FINAL PLANS
FOR REVIEW ONLY
NOT FOR CONSTRUCTION

SITE-UTILITY PLAN

FAMILY DOLLAR STORE
709 S. 16TH STREET
WILMINGTON, NC

File No. 14001
Scale: 1" = 20'
Sheet No.
C-001

1 SITE-UTILITY PLAN
SCALE: 1" =20'

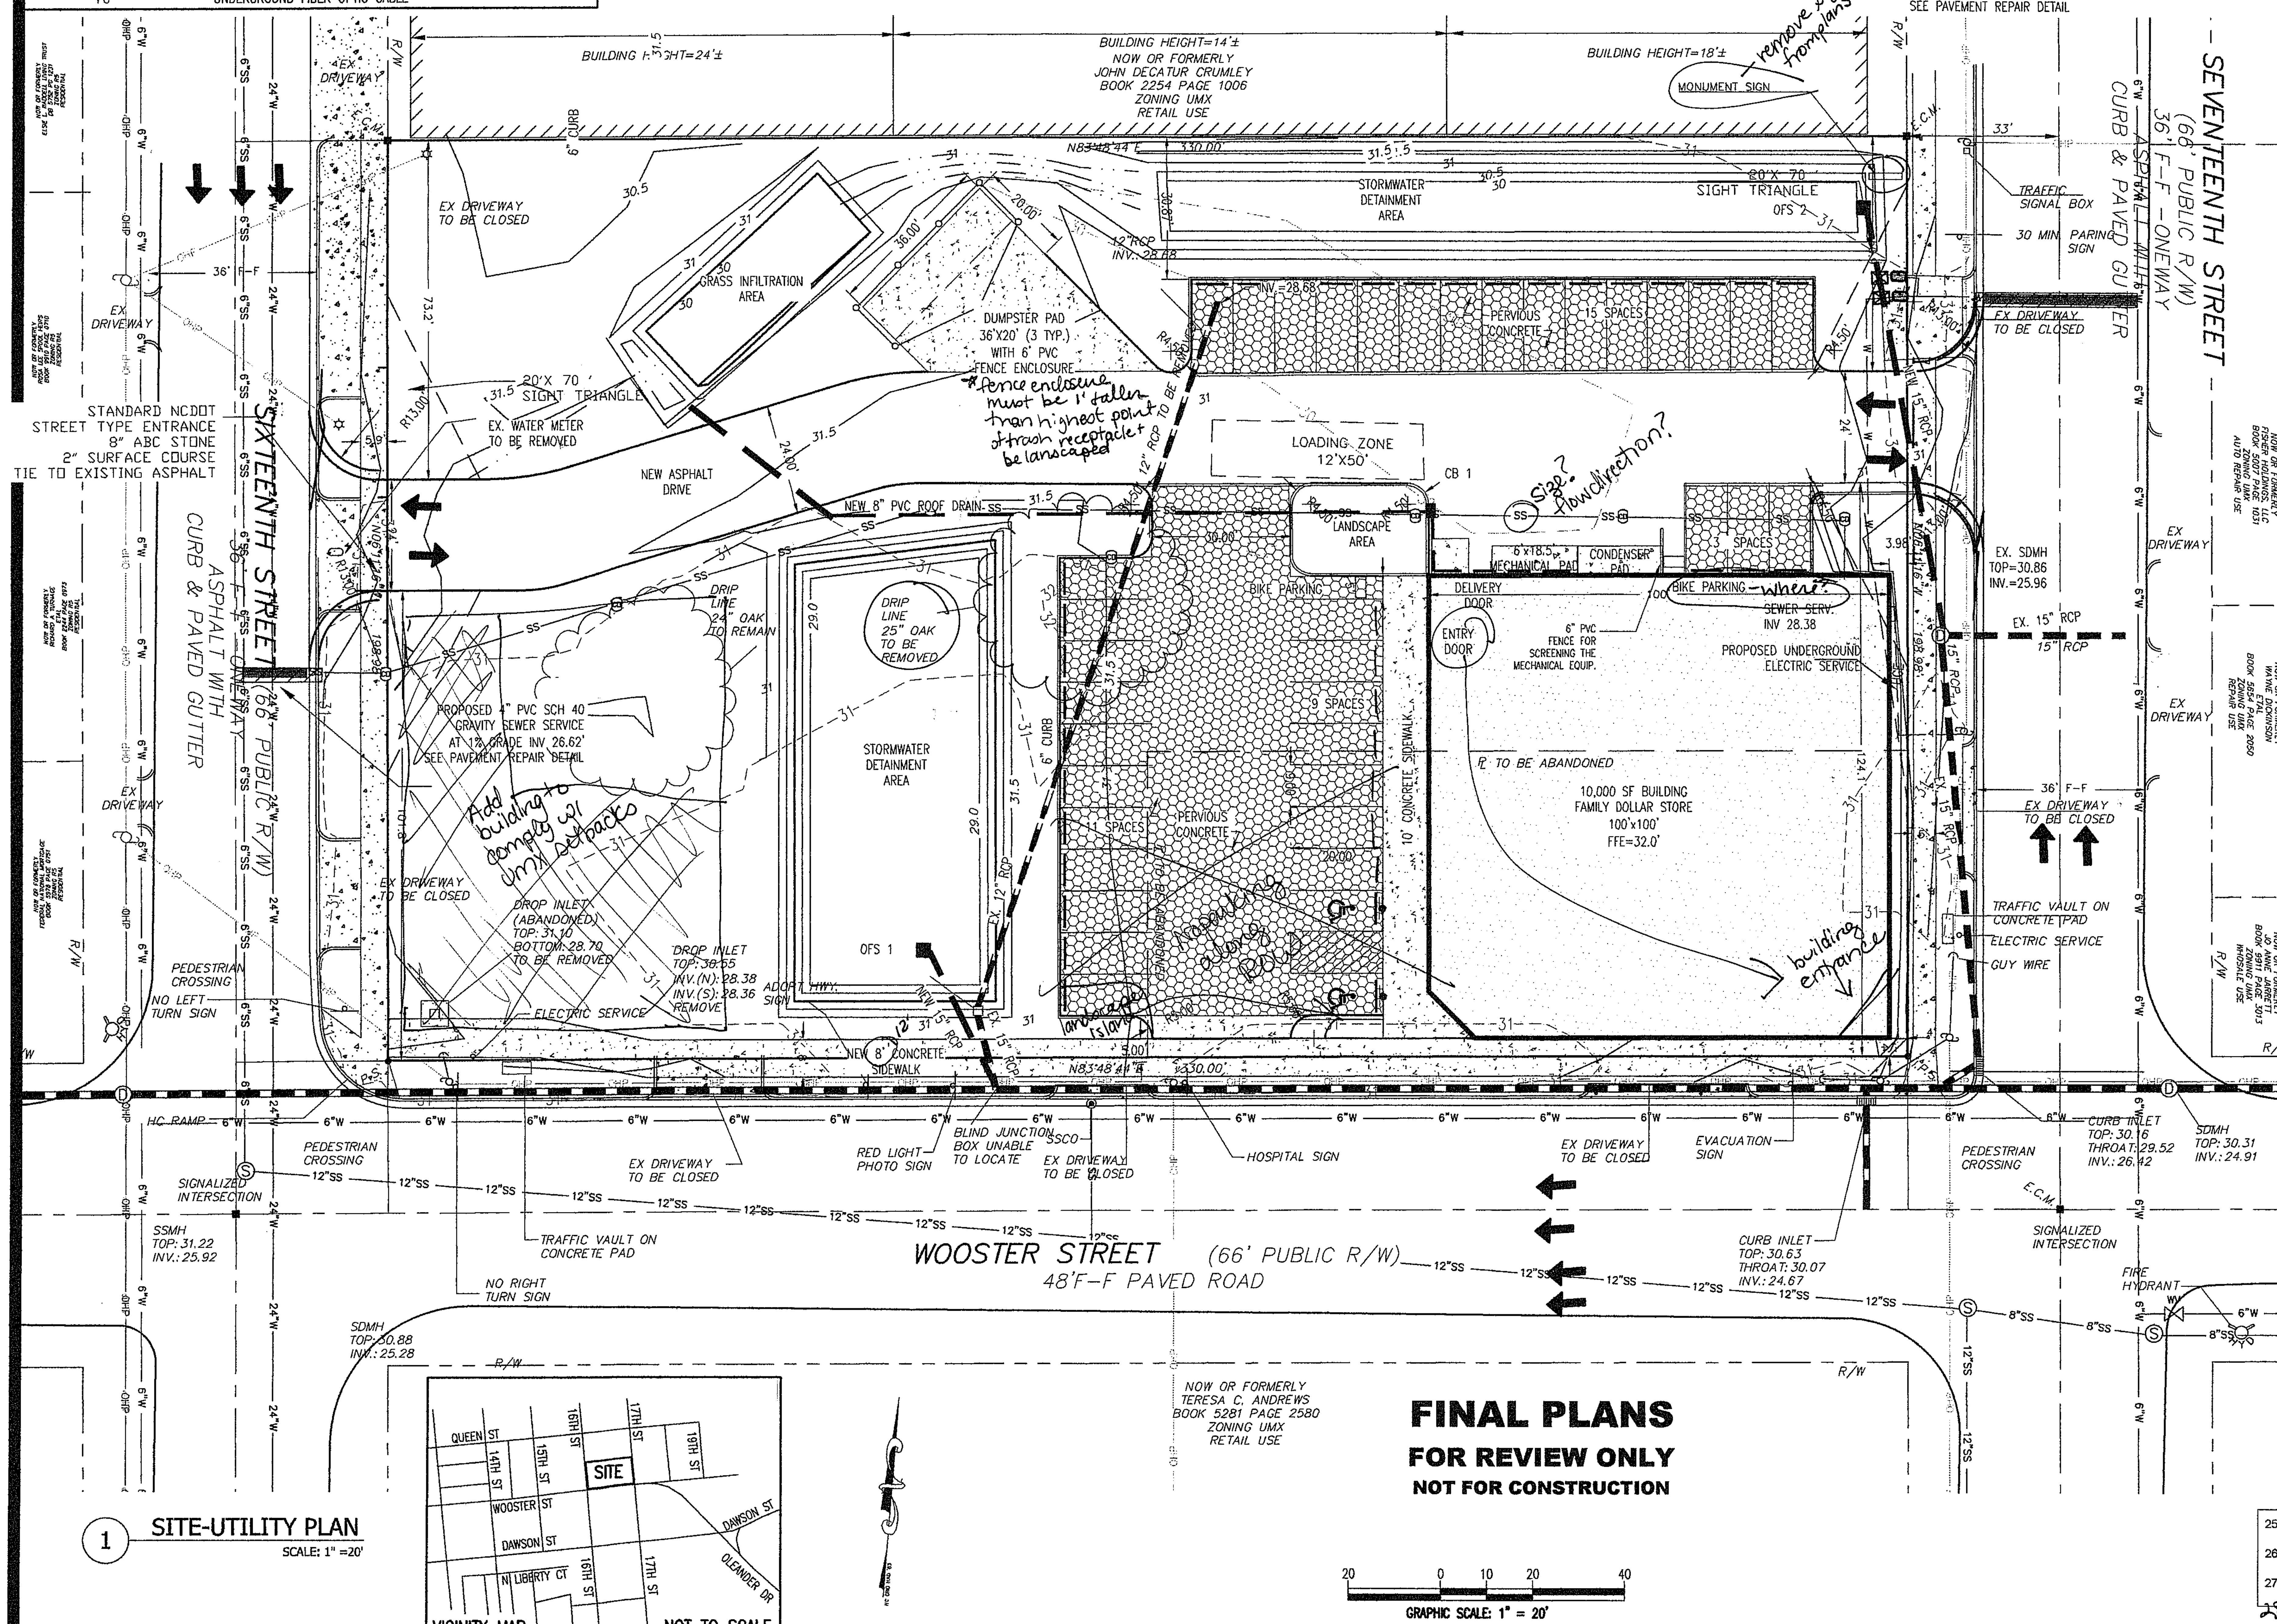
ZONING INFORMATION:
PARCEL ID NO. - 312710.45.4701&3500
SITE ZONING: UMX
SETBACKS:
MINIMUM BUILDING SETBACKS (UNLESS NOTED)
FRONT: 0' - MAX. 10' MAX HEIGHT - 45' Proposed 4'
SIDE: 0' 4'
REAR: 0' - 94.78'
BUILDING HEIGHT: 20' — max 10' setback "In no case shall front setbacks exceed 10 feet"

CAMA LAND USE CLASSIFICATION
URBAN ~~SERVICE AREA~~

SIGHT LIGHTING
ALL SIGHT LIGHTING SHALL BE LOCATED, ANGLED SHIELDED, AND OR LIMITED IN INTESITY SO AS TO CAST NO DIRECT LIGHT UPON ADJACENT PROPERTIES, SHALL MINIMIZE OFF-SITE BACKLIGHTING GLARE, AND UP LIGHTING. LIGHT POST SHALL B NO TALLER THAN ~~TWELVE~~ [illegible] FEET.

PARKING REQUIREMENTS:
PARKING SPACES TO BE TYPICAL (9 FEET X 18 FEET) UNLESS OTHERWISE NOTED
REQUIREMENTS
~~PARKING SPACES REQUIRED: 50 MAX~~ No parking requirement in UMX
PARKING BUILDING CODE REQUIREMENTS:
1 SPACE PER 200 SF RETAIL MAX.
PARKING PROVIDED TOTAL: 31
HANDICAPPED ACCESSIBLE: 2
HANDICAPPED ACCESSIBLE PARKING TO BE (2 EQUAL SPACES) PER LOCAL CODE

BICYCLE PARKING -
REQUIRED: ~~1 PER 1000 SF GFA~~ [illegible]
PROVIDED: 10 SPACES
line up table so its clear this is bicycle parking

1. Prior to any clearing, grading or construction activity, tree protection fencing shall be installed around protected trees or groves of trees. No construction workers, tools, materials, or vehicles are permitted within the tree protection fencing. and posted w/ signage in English + Spanish that trees are to be
